UNITED STATES
DEPARTMENT OF THE INTERIOR
BUREAU OF LAND MANAGEMENTFORM APPROVED
OMB NO. 1004-0137
Expires: January 31, 2018**SUNDRY NOTICES AND REPORTS ON WELLS**
Do not use this form for proposals to drill or to re-enter an abandoned well. Use form 3160-3 (APD) for such proposals.5. Lease Serial No.
NMLC063875

POKER LAKE UNIT 27 BD 106H

XTO Permian Operating, LLC, requests permission to make the following changes to the original APD:

PECOS DISTRICT DRILLING CONDITIONS OF APPROVAL

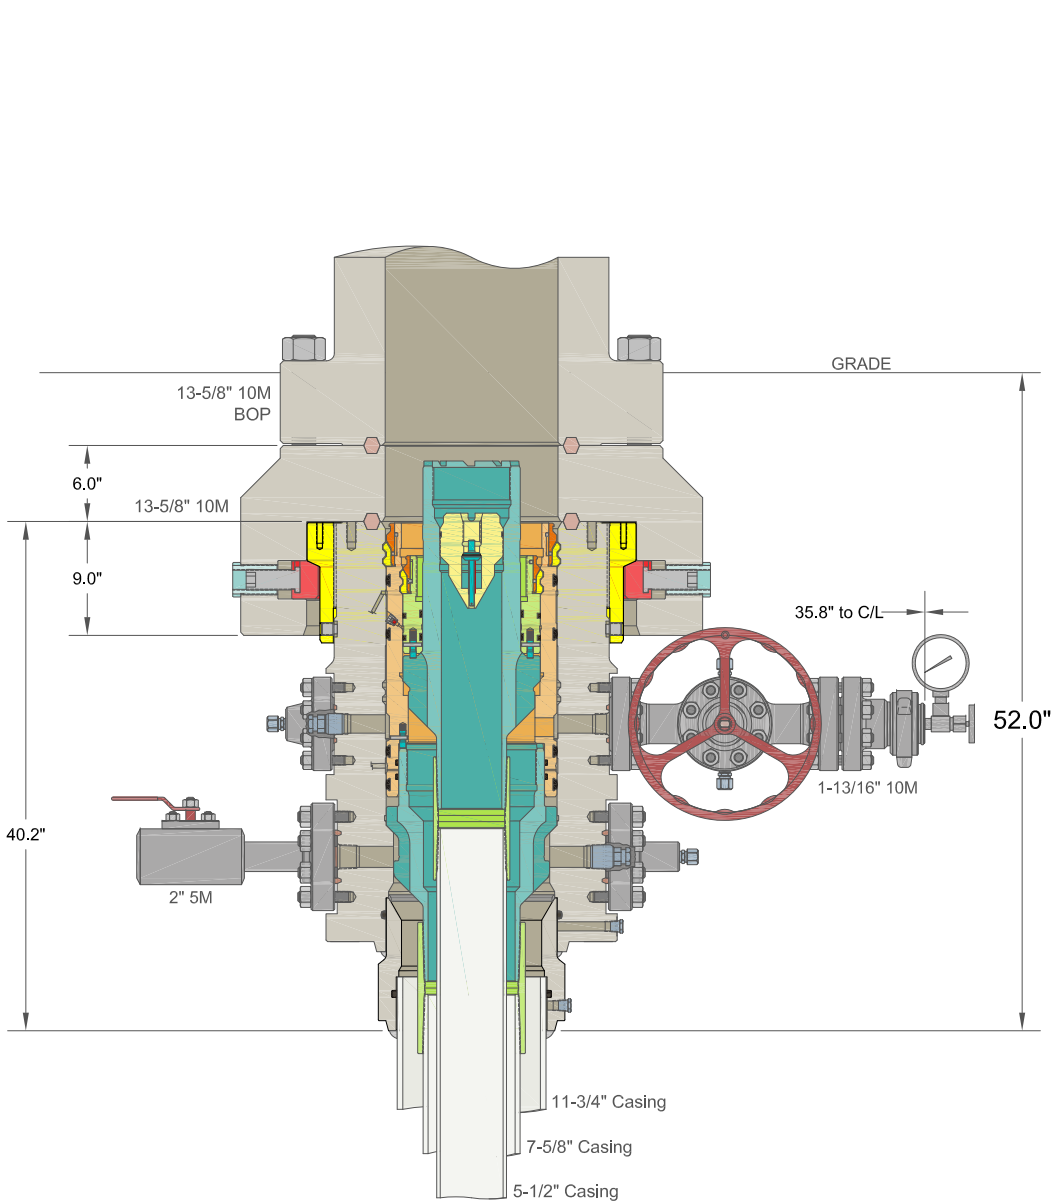
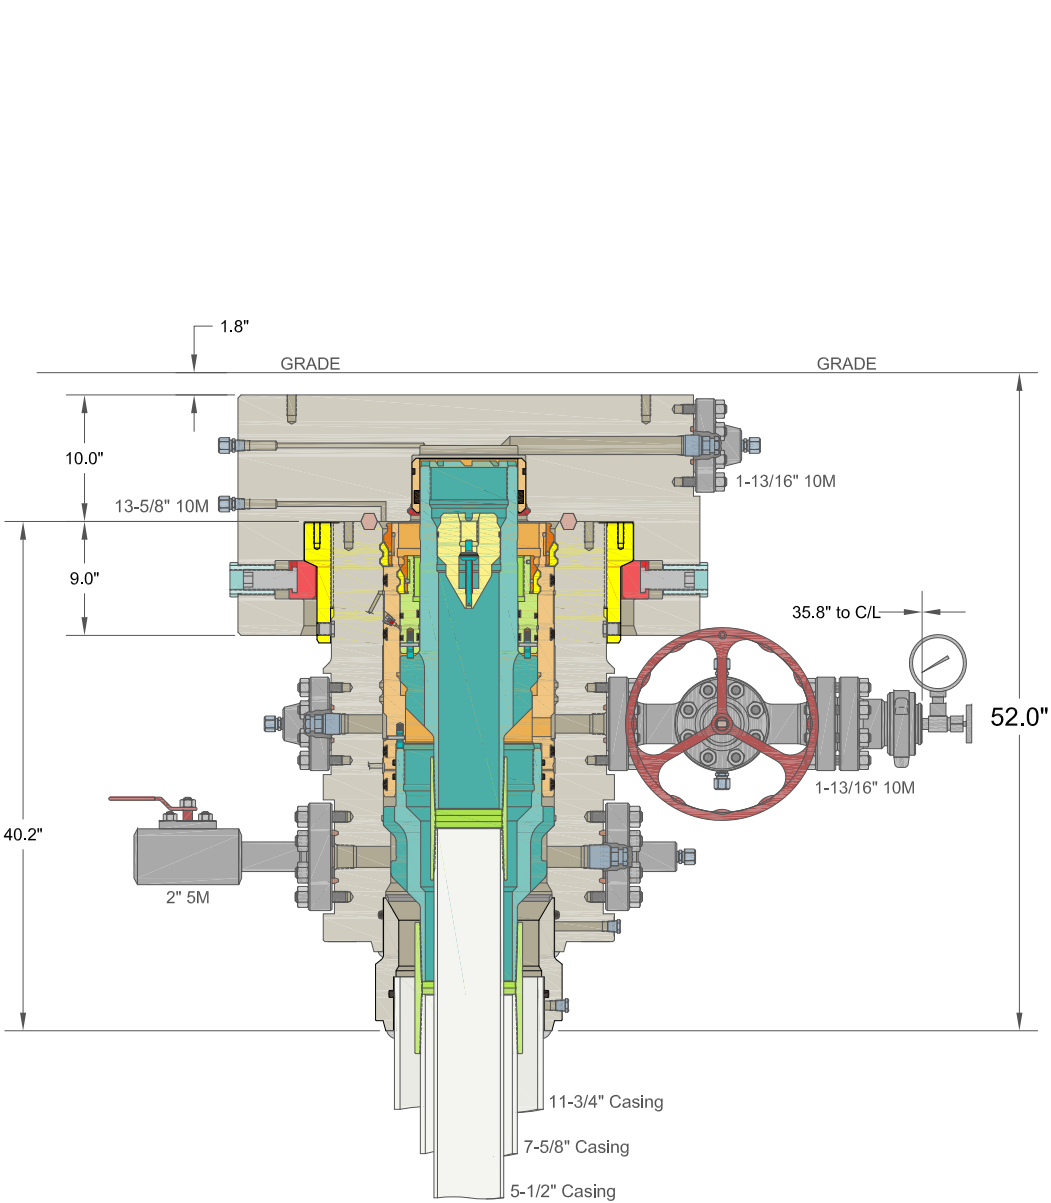
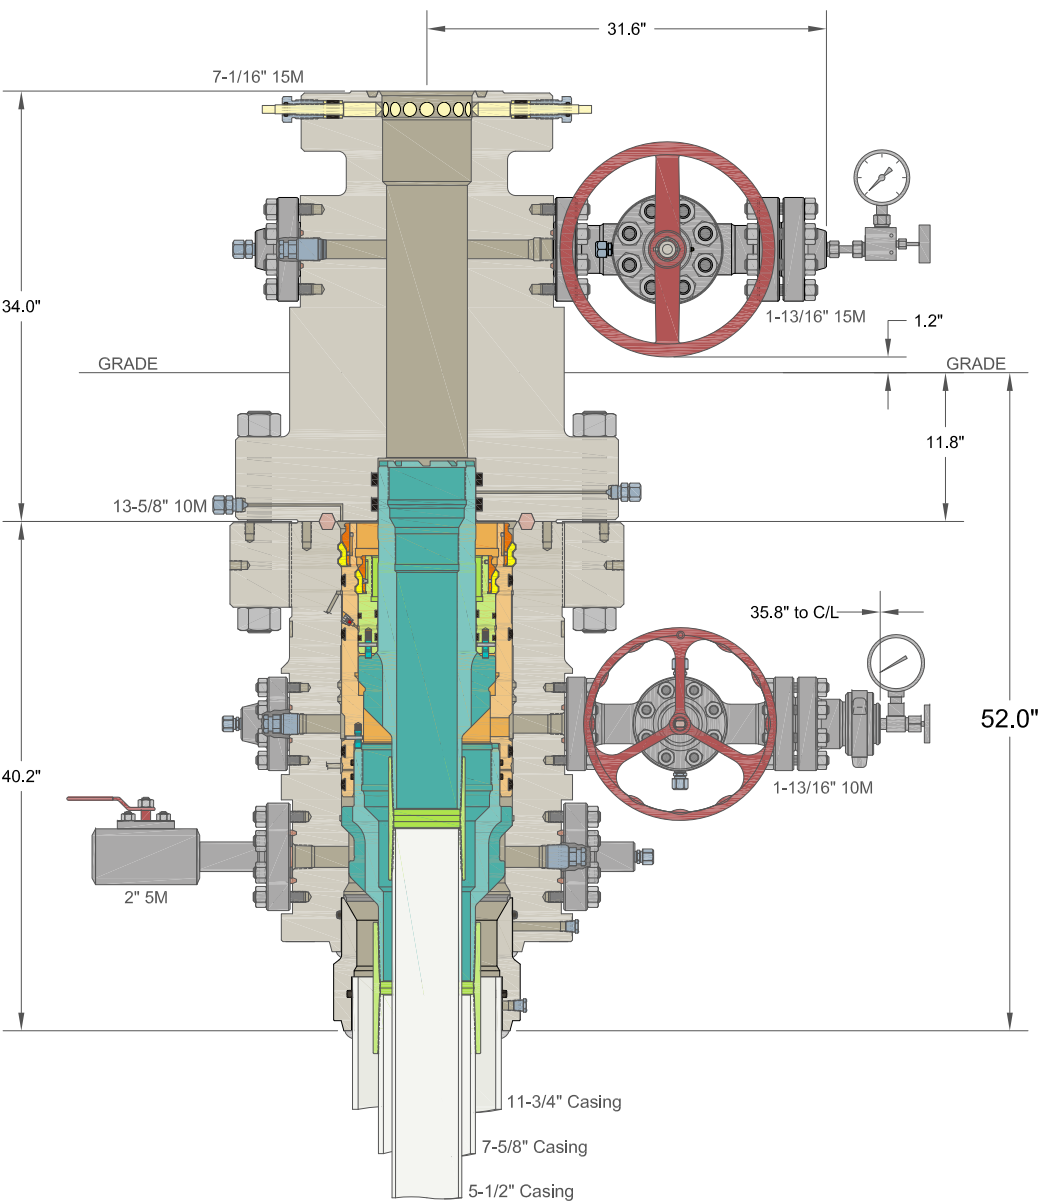
Permanent Wellhead – Multibowl System

A. Starting Head: 13-5/8" 10M top flange x 11-3/4" SOW bottom

B. Tubing Head: 13-5/8" 10M bottom flange x 7-1/16" 15M top flange

Wellhead will be installed by manufacturer's representatives.

Manufacturer will monitor welding process to ensure appropriate temperature of seal.

2. Operator has proposed a multi-bowl wellhead assembly. This assembly will only be tested when installed on the surface casing. Minimum working pressure of the blowout preventer (BOP) and related equipment (BOPE) required for drilling below the surface casing shoe shall be **5000 (5M)** psi.

- a. Wellhead shall be installed by manufacturer's representatives, submit documentation with subsequent sundry.
 - b. If the welding is performed by a third party, the manufacturer's representative shall monitor the temperature to verify that it does not exceed the maximum temperature of the seal.

- c. Manufacturer representative shall install the test plug for the initial BOP test.
 - d. If the cement does not circulate and one inch operations would have been possible with a standard wellhead, the well head shall be cut off, cementing operations performed and another wellhead installed.

Note: Picture below highlights BOP components that will be tested during batch operations

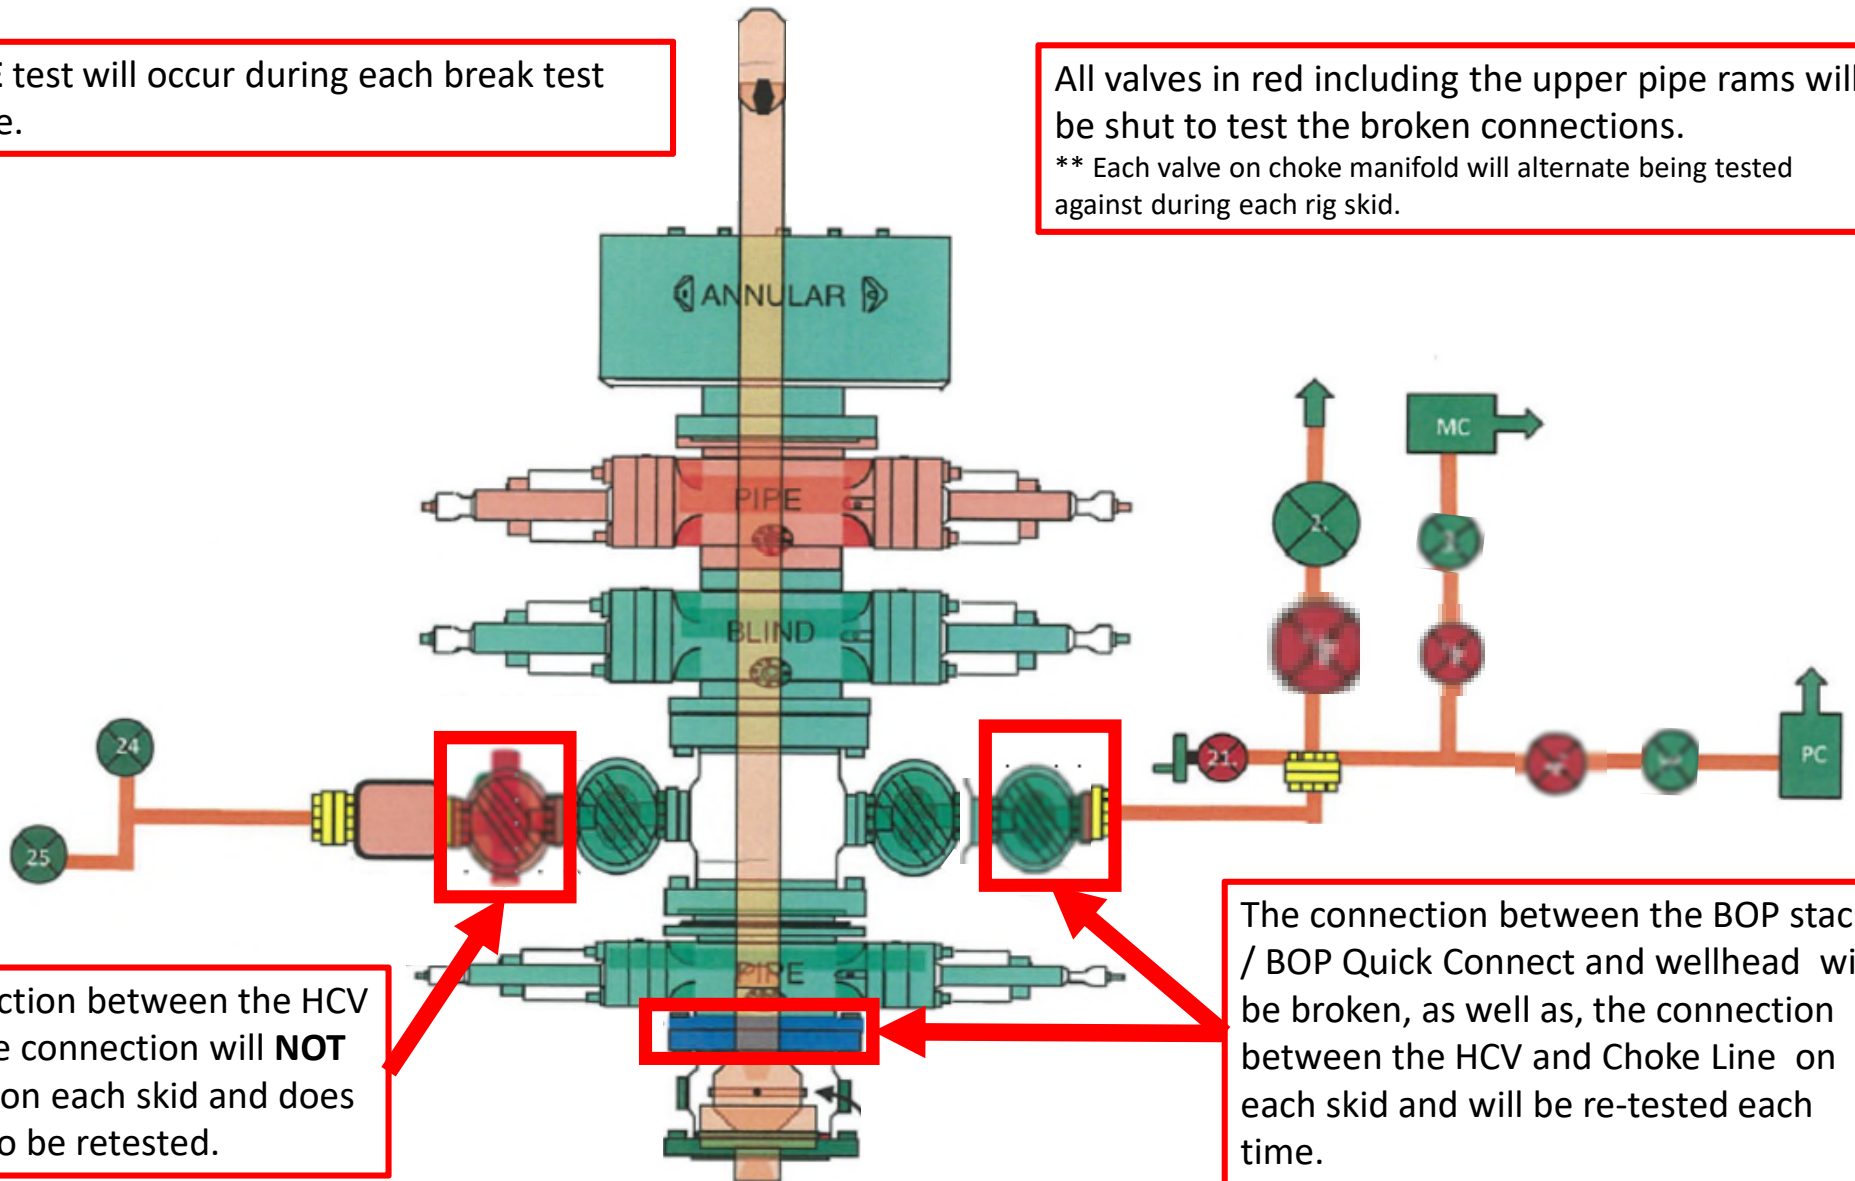
All valves in red including the upper pipe rams will be shut to test the broken connections.
** Each valve on choke manifold will alternate being tested against during each rig skid.

The connection between the HCV and kill line connection will **NOT** be broken on each skid and does not need to be retested.

The connection between the BOP stack / BOP Quick Connect and wellhead will be broken, as well as, the connection between the HCV and Choke Line on each skid and will be re-tested each time.

- Shell testing is not approved for any portion of the hole with a MASP of 5000 psi or greater.
- While in transfer between wells, the BOPE shall be secured by the hydraulic carrier or cradle.
- Any well control event while drilling require notification to the BLM Petroleum Engineer prior to the commencement of any BOP Break Testing operations.
- A full BOP test is required prior to drilling the first deep intermediate hole section. If any subsequent hole interval is deeper than the first, a full BOP test will be required.
